Report to the Sydney Western City Planning Panel on an application for a site compatibility certificate - State Environmental Planning Policy (Housing for Seniors or People with a Disability) 2004

SITE: 121-133 Prairie Vale Road, Bossley Park (part Lot 7 DP 664803 and part Lot 1 DP 332770). The land subject to the proposed seniors housing development has an area of 1.5ha. The site is part of the larger Club Marconi site and is proposed to be located above an existing car park.

PROPOSAL: Seniors housing village.

Figure 2: Proposed concept plan.

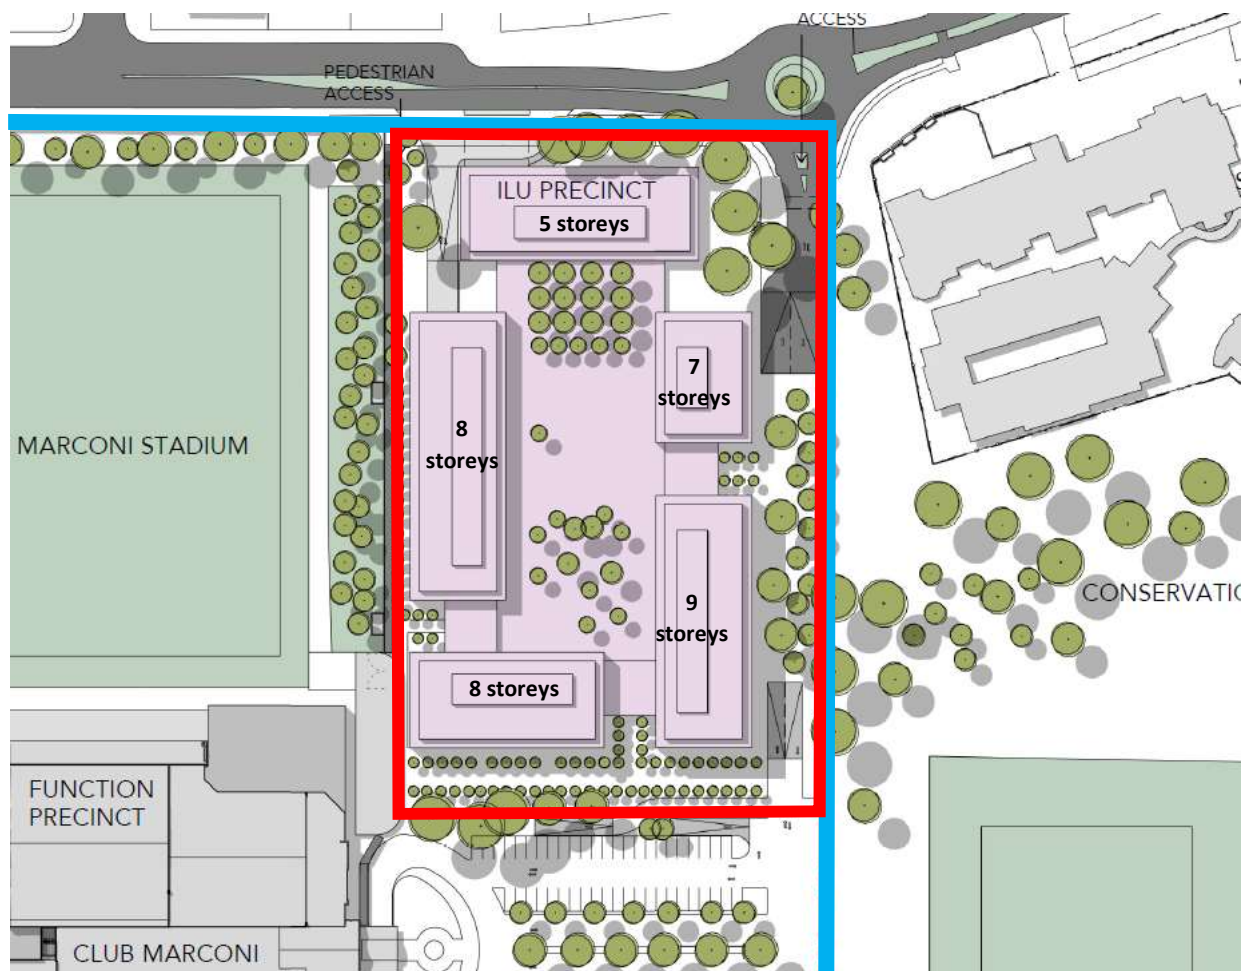
The maximum height of the proposed seniors development ranges from 15m for the five-storey building to 28m for the nine-storey building, including lift overruns and the existing parking structure below.

Figure 3: Proposed Club Marconi redevelopment concept plan.

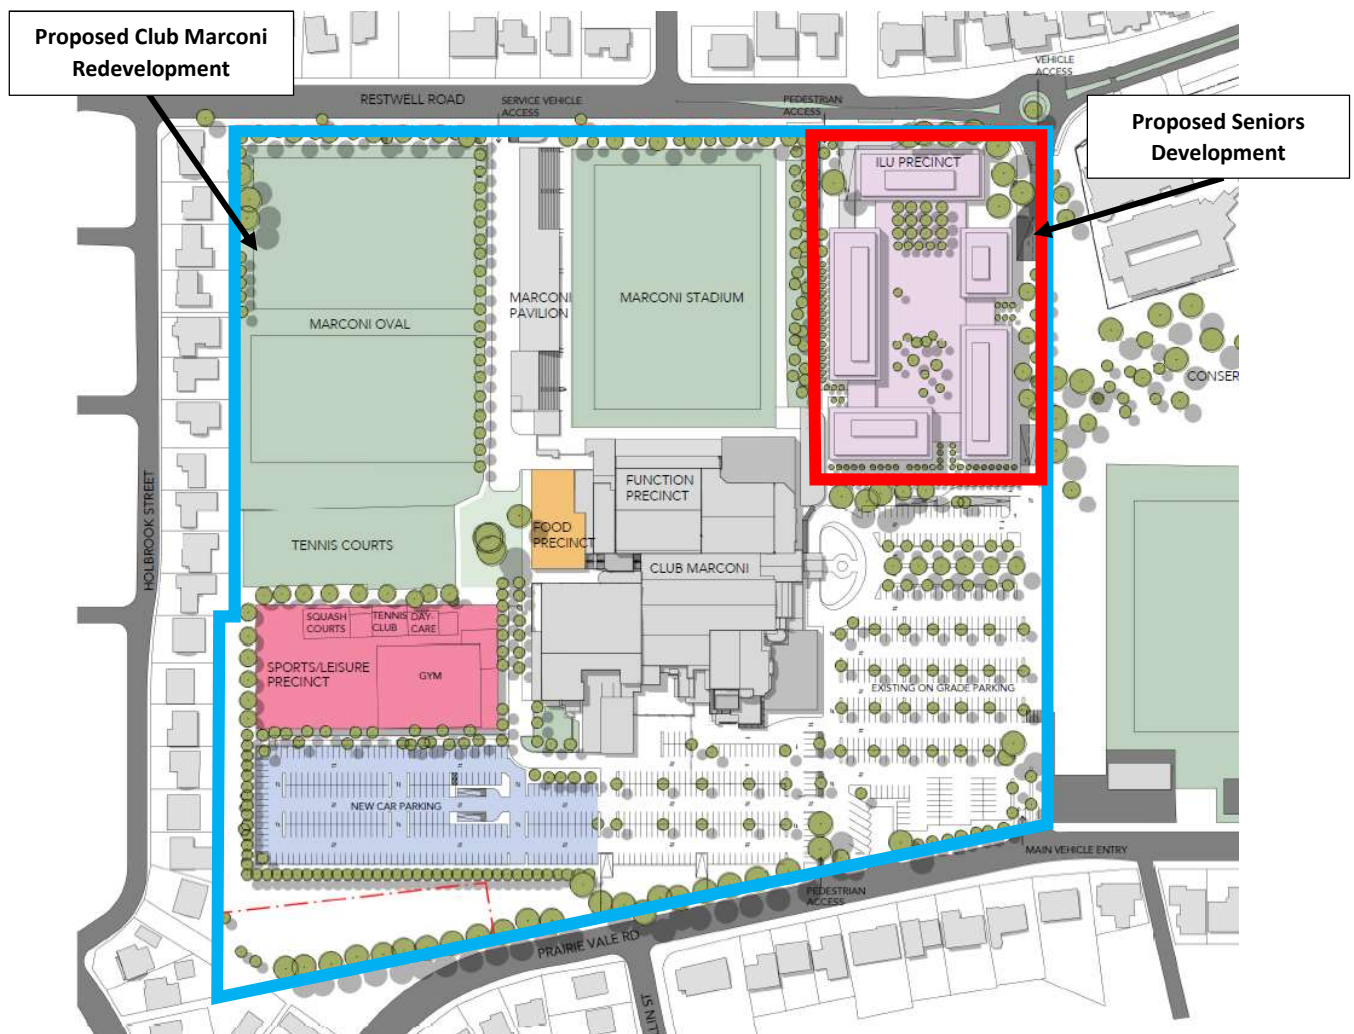
However, it is noted that the proposed concept plan for the redevelopment of the entire Club Marconi site (refer to Figure 3 on page 3) involves the removal of the training field in the southwest corner of this site for additional parking and an expanded sports precinct. Therefore, this will reduce the current area of the club site which is used for recreational purposes but not negatively impact the current use.

Council advised that the SCC application has not considered the cumulative impact of the proposed redevelopment of the broader Club Marconi site. Therefore, Council recommends that a comprehensive masterplan and urban design assessment of the entire redevelopment be provided at the development application stage.

The Department acknowledges the scale and the possible cumulative impacts of the proposed redevelopment of the broader Club Marconi site, including the seniors housing development, on the surrounding area.

Therefore, it is recommended that the SCC be imposed with a requirement to consider the proposed seniors development in association with any future

redevelopment of the Club Marconi site via a comprehensive masterplan and urban design study.

- State Environmental Planning Policy No 65—Design Quality of Residential Apartment Development and the Apartment Design Guide.
3. Any development application is to be supported by a concept masterplan for the entire site which addresses the outcomes of the urban design review.

Figure 9: Landscape and Open Space Plan

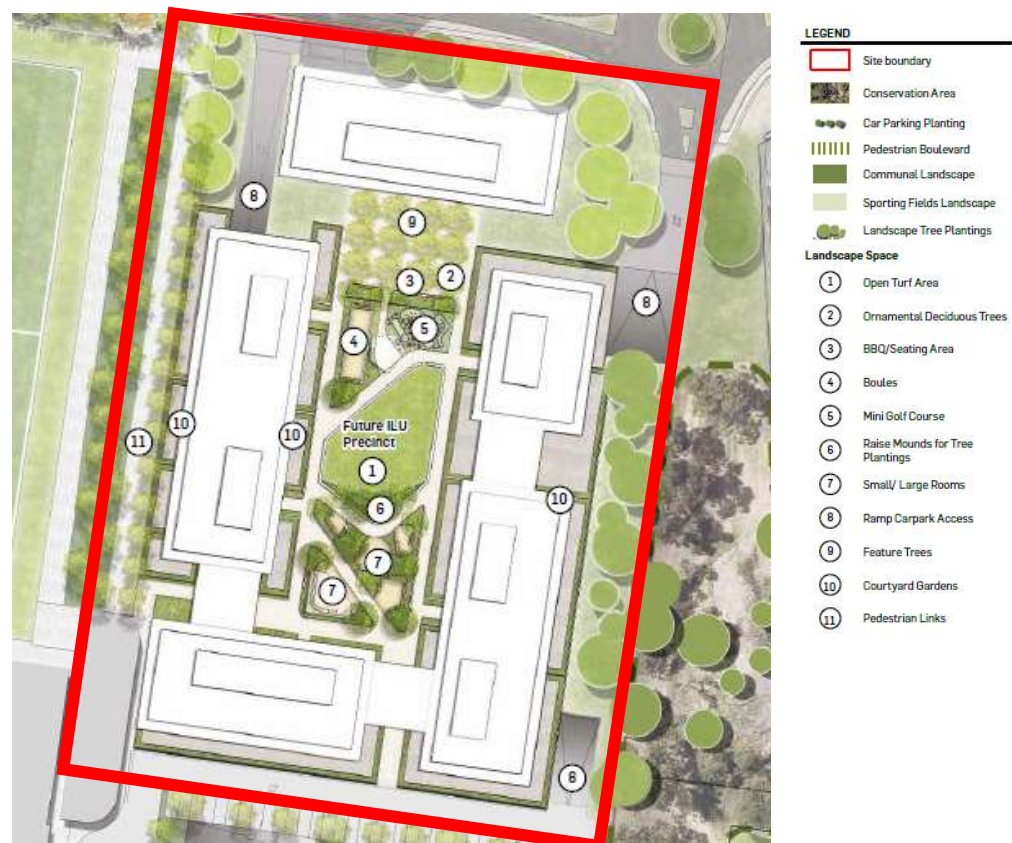
The site is within walking distance of public open space (i.e. Marconi Park), and the proposed seniors development includes the provision of a central communal courtyard. The design package (see page 27 of **Attachment B3**) identifies seated areas and recreational uses within the courtyard, which address Council's concerns (Figure 9 below). Therefore, there is sufficient open space within the vicinity of the site and provided on the site to meet the needs of the proposed seniors residents.

Figure 11: North-south cross-section extracts.

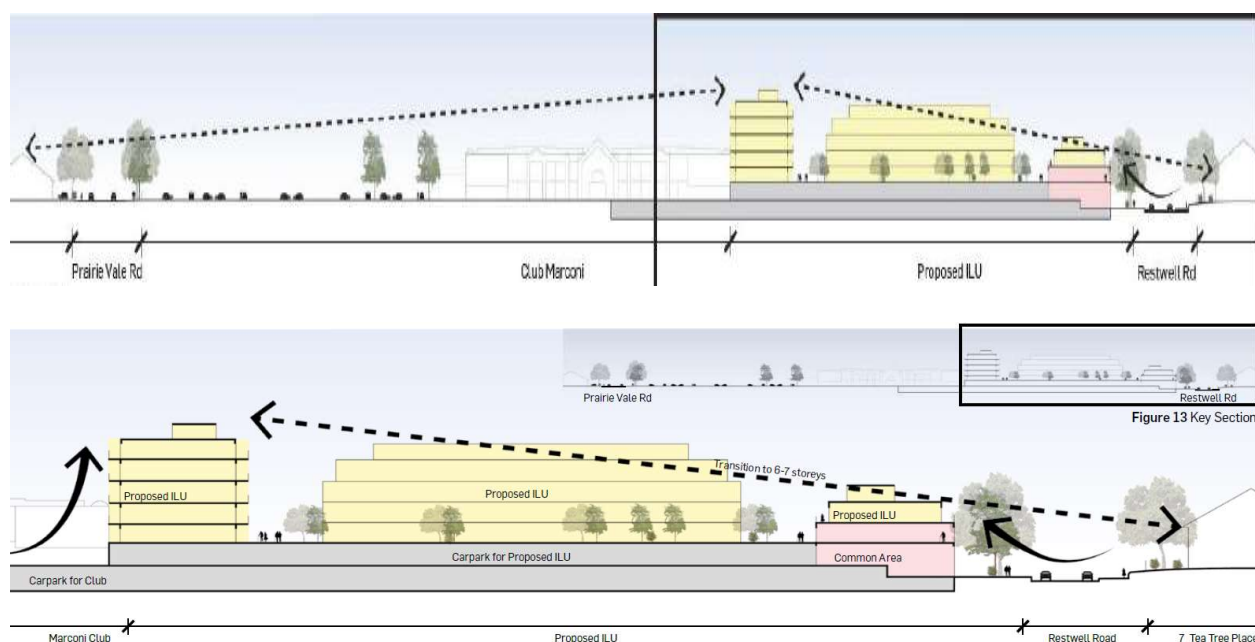
The top floor (not the lift overrun) of each building will be set back within the building footprint to minimise visual impact of the buildings. This will result in a two-storey interface with the existing residential development along Restwell Road (Figure 11 below). The Department notes that a two-storey interface is considered to be an appropriate mitigation measure.

As shown in Figure 11, the height of the proposed seniors development gradually increases from two to four storeys along Restwell Road to eight to nine storeys towards the rear of the site.

The proposed seniors development is proposed to have heights ranging from 15m to 28m, which is not considered compatible with the surrounding two-storey low-density residential area, which has a maximum height control of 9m.

The proposed development outcome will be more consistent with a residential flat building typology, which is only permitted (with consent) in the R4 High Density Residential and B4 Mixed Use zones. Residential flat buildings are not permitted in the surrounding R2 Low Density Residential zone. Further, within the LGA, the maximum building heights in the R4 and B4 zones are generally 18m (approximately six storeys). Therefore, the bulk and scale of the proposed development would be more suited for areas zoned R4 and B4 instead of this site, which is surrounded by an R2 zone.

In these circumstances, the Department recommends that the SCC be imposed with a requirement for Council to review the height and bulk of proposed buildings to be

consistent with the character of the surrounding area to ensure the proposed building will not dominate the streetscape.

1. An urban design review addressing the bulk, scale and height of the proposal in relation to the existing urban areas is to inform the final height of building and accompany any development applications.

Figure 12: Proposed overshadowing on 21 June at 9am and 3pm.

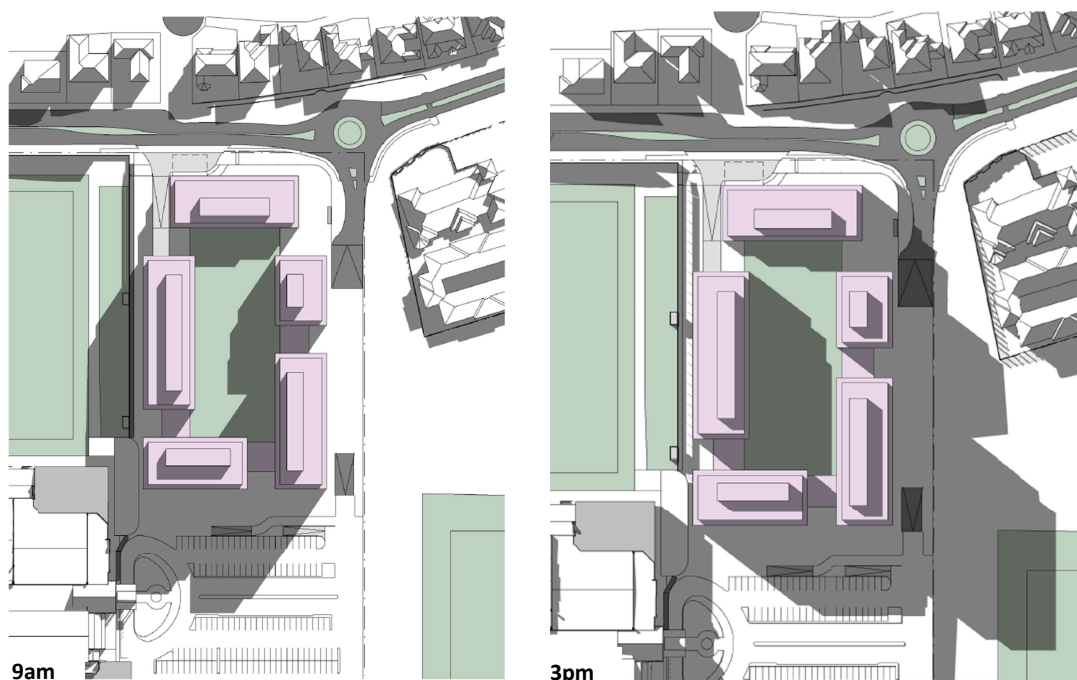
The shadow diagrams (page 35 of **Attachment B3**) illustrate that the proposed development will create additional overshadowing across the Club Marconi car park and minor shadow over Marconi Park after 3pm (Figure 12 below). A large portion of the central communal courtyard will also be overshadowed during the winter solstice at 9am and 3pm.

The shadow diagram may change as further investigations into the final bulk and scale of the proposed development are undertaken at the development application stage. It is recommended that overshadowing of Marconi Park is avoided to ensure there is no impact on the current quality of the public open space.

- internal and external overshadowing including no shadow cast over Marconi Park;
 - privacy of adjacent private property;
 - traffic, pedestrian mobility and access; and
